**Bellemont Area I-40 TI DCR Update
ADOT Project No. 40 CN 182 T0490 03L
Federal Aid No.: TBD**

January 2025 Public Meeting Summary Report

Alternative 2 – Diverging Diamond

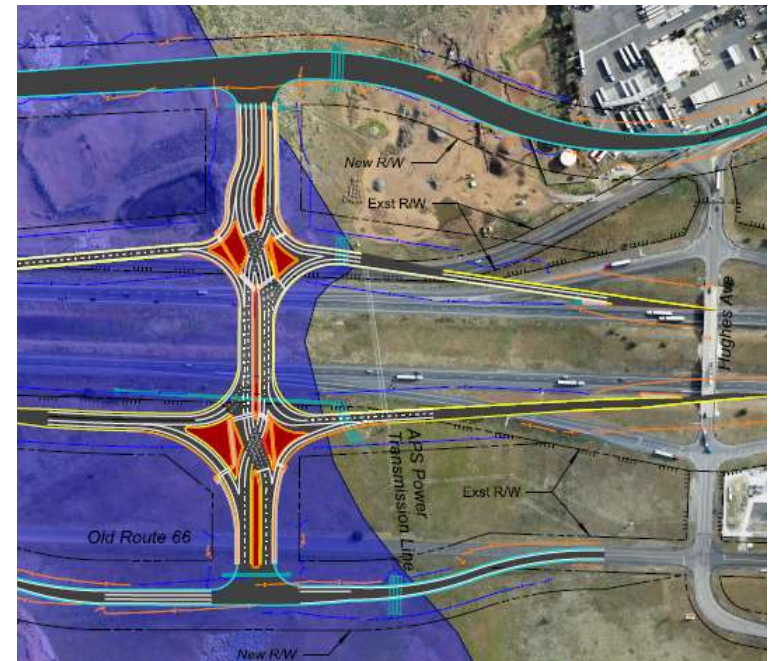
In-Person	ADOT 2	What is the plan for snow removal on this plan?	Snow removal would be done in a manner similar to how it is done today.
In-Person	ADOT 2	Anything that keeps trucks and residents together is a recipe for disaster. Create a different road/Pilot access for trucks to the West of the Pilot. Stop allowing them to backup the roundabout.	Thank you for your comment. Several of the alternatives would provide greater separation between residential traffic and truck stop traffic than exists today.
In-Person		The options provided are short sided and ultimately aim to benefit the corporate and the newcomers. Just like we did the natives. Thank you for forgetting about the locals!	The proposed alternatives are primarily designed to improve connectivity and access for all users.
In-Person	ADOT 6A & 7A	Alternative 6A & 7A are by far the most ideal to provide more emergency access and egress points to a growing community in a fairly risky fire area. The addition of County Road access around the back of the Pilot station would further this goal for safety.	Thank you for your input. ADOT appreciates your comments and support for this improvement project.

Online	ADOT #2	<p>Alternative 2 - Diverging Diamond: How does this option change or streamline the entrance / exit for the trucks at Pilot? How does this option allow for any future development (e.g., another truck stop or other retail) with relation to the current roundabout on Shadow Mountain? This option seems like it would not be conducive for the current businesses or neighborhood who would have to go 0.25 miles beyond their destination if traveling from Flagstaff.</p>	A major benefit of Alternative 2 is that is provides greater separation between the interchange and the truck stop and residential neighborhood.
Online	ADOT #6A	<p>Alternative 6A seems the best to me. This would leave the normal existing exits for the trucks and allow the bellemont neighborhood its own exit.</p>	Thank you for your input. ADOT appreciates your comments and support for this improvement project.

Alternative 6A – Add TI One Mile East

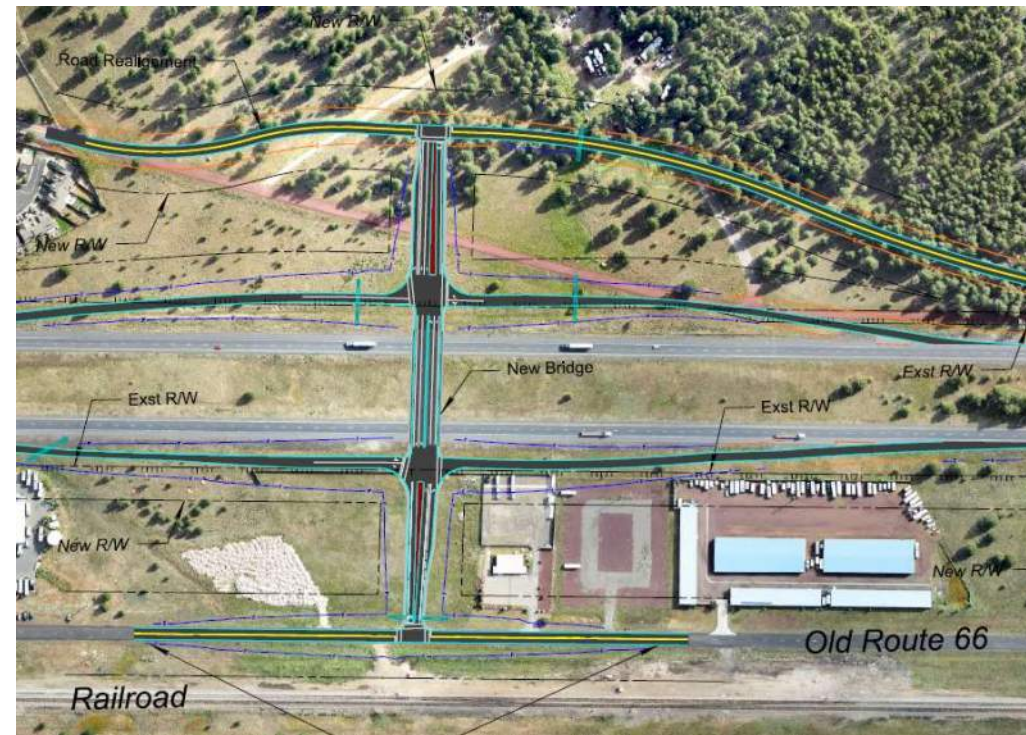
Email	ADOT 6A	We think the Alternative 6A – Add TI One Mile East would be the best for our neighborhood.	Thank you for your input. ADOT appreciates your comments and support for this improvement project.
Online	ADOT #2 & #3	Alternative 3 looked best from the perspective of a Bellemont resident, though Alternative 2 was a good backup option. Both looked to do a good job allowing residents to exit the I-40 and make it home without being stuck behind diesels, though getting to the freeway with any of the options will still be problematic - diesels seem to get stopped/stuck in front of the pilot all the time. Another benefit of options 3 and 2 are that we would avoid the use of traffic signals. Of course, the real fix is to place a second free exit/on-ramp on the east side of the Bellemont community.	Thank you for your comments.
Online	ADOT #7A	<p>Alternative 7a is a preferred alternative providing easy access to the residences with access to/from Flagstaff. Signage would be suggested to prevent truck traffic from using and putting a ton of commercial truck traffic down Shadow Mountain Dr. This option would provide egress in the event of an emergency (esp. wildfire) which at present there is only one way in/out of Bellemont. 6a is an acceptable alternative but since traffic can head west from the existing Hughs ave onramp, this option seems like lots of extra cost with little benefit. Alternatives 4 and 5 should be non starters! The use-case does not justify the impact to residential properties, especially when building in on unimproved commercial/residential properties is easily achieved (e.g alternatives 2 and 6 or 7)</p> <p>Alternative 3 would be a fine option, but I'm not sure most of the 18 wheelers using this exit can navigate a straight line- i easily foresee them going the wrong way</p> <p>Preferred order of preference, 7a, 2, 6a,3, 1.</p>	Thank you for your input. ADOT appreciates your comments and support for this improvement project.

Email	ADOT 6A	6A, looks best. Just changing Hughes still does not give us residents an alternate way in or out when the bridge or current roundabout is blocked.	Thank you for your input. ADOT appreciates your comments and support for this improvement project.
Online	ADOT 6A	The only option that seems the most feasible is adding another exit to the east of the housing developments (Plan 6A) and creating signage there to instruct the commercial trucks to use the old exit. That other exit also needs to be redesigned, like in the plans presented, so that we no longer have the roundabout. Driving issues, snow removal/ice, and emergency exits are all among reasons that I support the 6A design. Noting that the fire department chose that as well during the meeting was something that I think should be heavily considered.	Thank you for your input. ADOT appreciates your comments and support for this improvement project.

Alternative 7A – Add Half-TI One Mile East

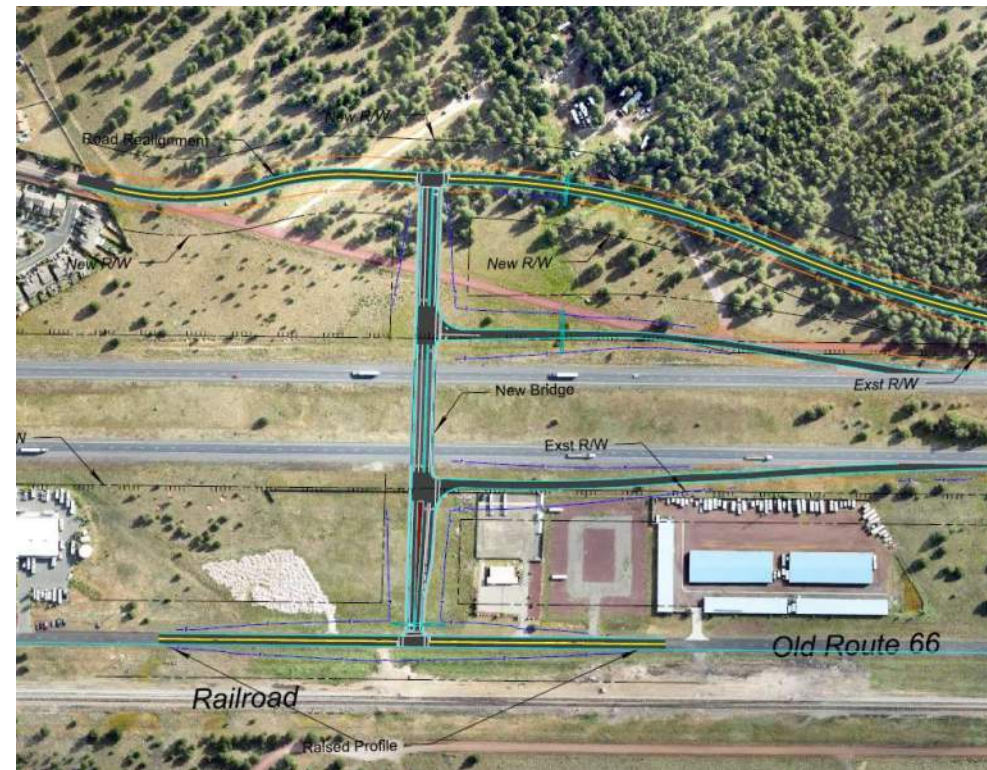
Online	ADOT #6A & #7A	Either 7A or 6A are appropriate. The community needs additional points of ingress and egress, and additional traffic lanes. Converting to a roundabout (either traditional or dogbone) does not resolve the "one lane" ingress and egress. In an emergency, including during an evacuation, the community needs multiple lanes for egress, and multiple lanes for the ingress of emergency personnel. ADOT and Coconino County must consider the longterm needs of the community, and 7A or 6A provide the best solution for the longterm needs of the community.	Thank you for your input. ADOT appreciates your comments and support for this improvement project.
Online	ADOT General	Most of the ideas were bad even given the conception back in 2013. The only ones that allow for any improvement especially given weather considerations are 6A and 7A. 6A is best and the only one supported by the fire department. I would like to know why the cost is so different between 6A and 7A given the similarities. The residents vocalized vast support and desire for 6A.	Thank you for your input. ADOT appreciates your comments and support for this improvement project. Alternative 7A would cost less than Alternative 6A because it requires construction of fewer ramps.
